04/19/2022

Subject: Change to SAE/USCAR-21, Rev 4 (Letter #5)

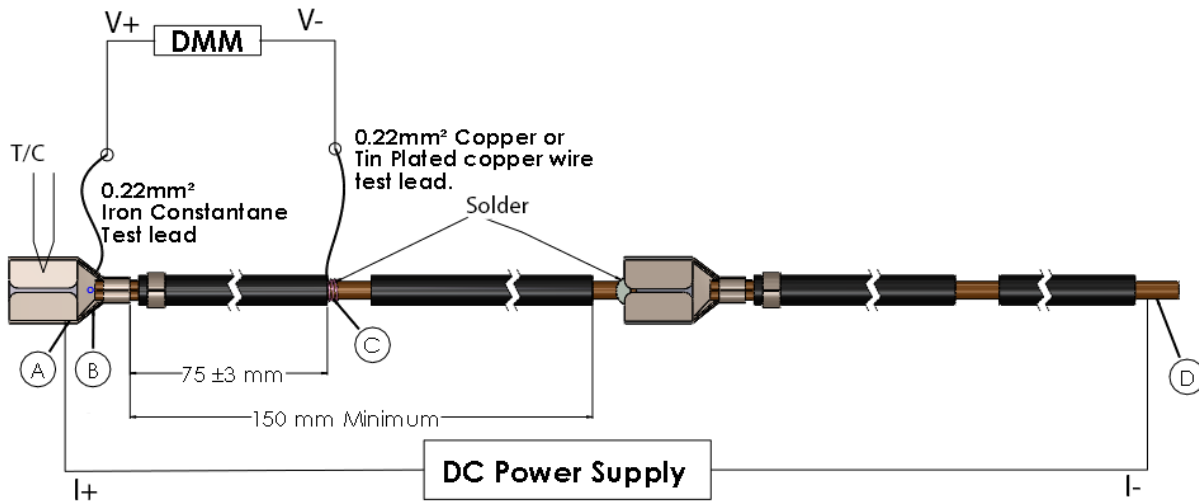
It was not clear which wires should be made of the thermocouple wire and which should be made of copper.

Changes have been made to the USCAR-21 specification. Figure 4.5.1.4, showing the 4-wire test probe set-up is more clear. Comments and questions can be sent to EWCAP@uscar.org.

Redraw Figure 4.5.1.4 as shown.
